SAN ANTONIO WATER SYSTEM
 DSP Southeast Tank and Pump Station Project
 SAWS Job Nos. 13-6102 (DSP) & 13-6005
 Solicitation No. CO-00006

ADDENDUM NO. 7

August 28, 2015

PZ830 Pump and System Curves (2018 Demands)

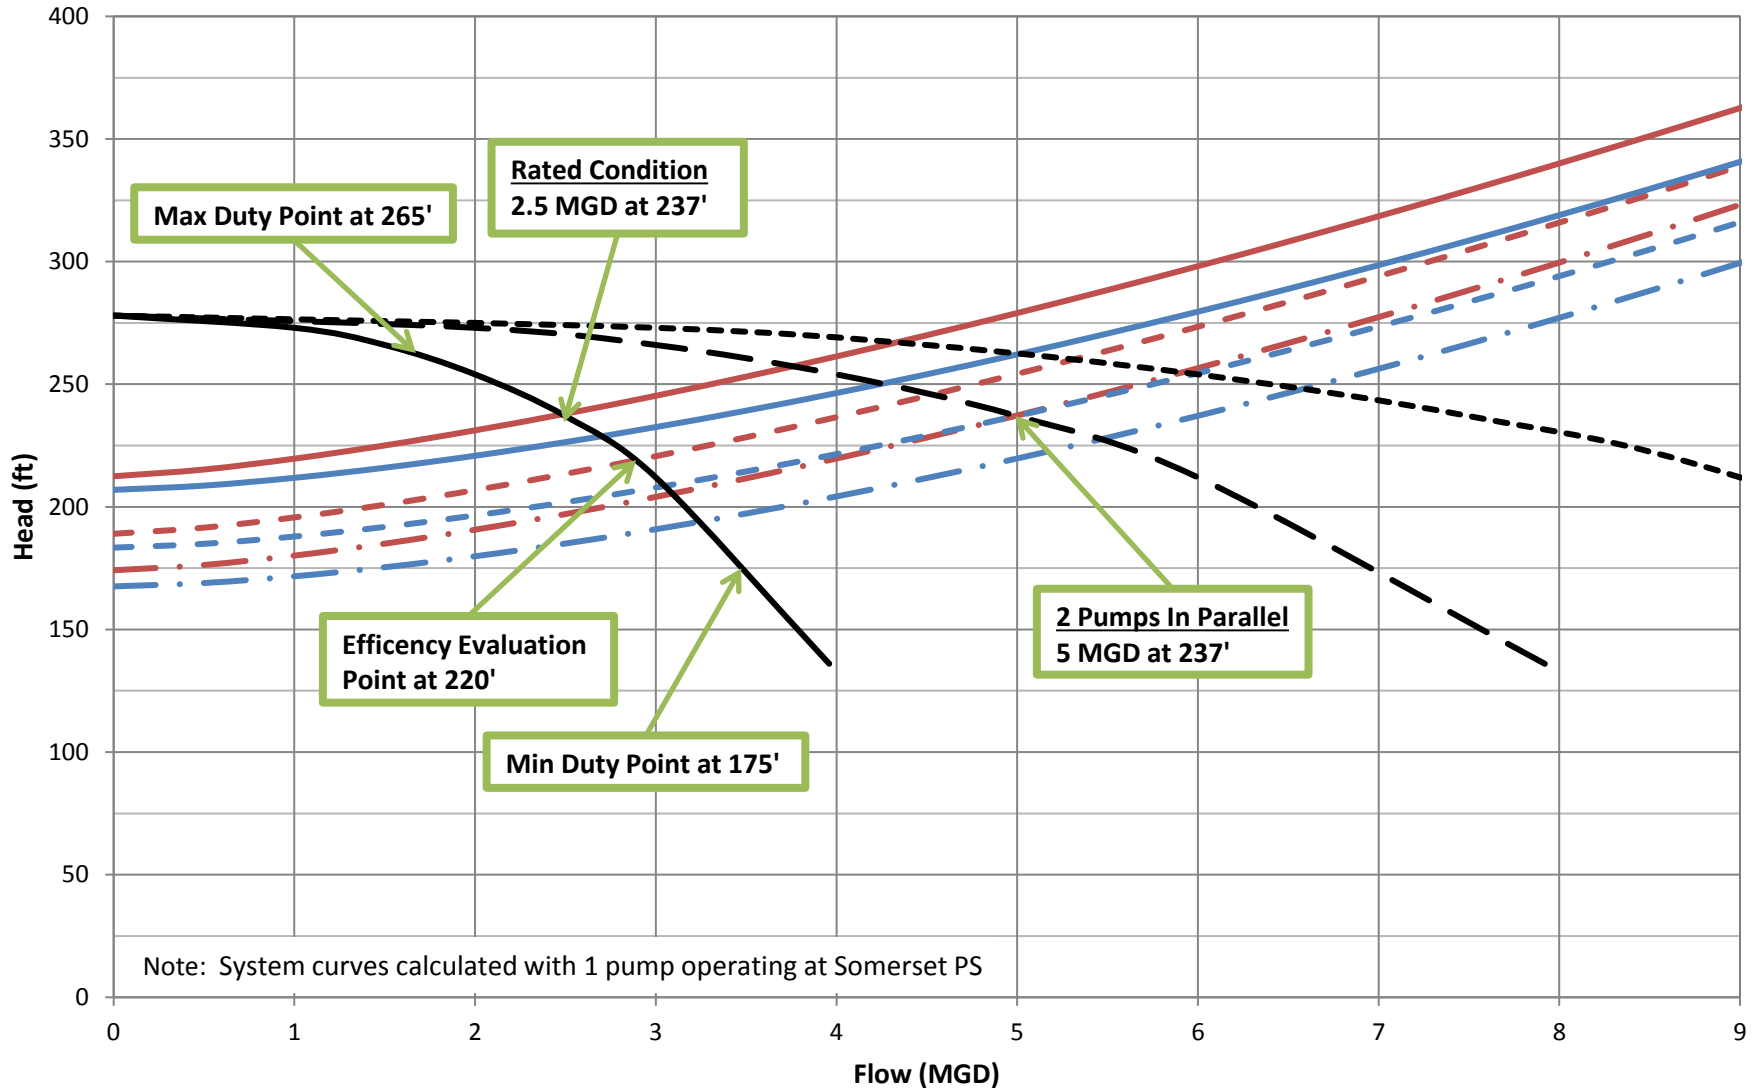
d. ADD the attached system curves to the end of Section 11210.

1. PZ830 Pump and System Curves (2018 Demands)
2. PZ2 Pump and System Curves (2018 Demands)
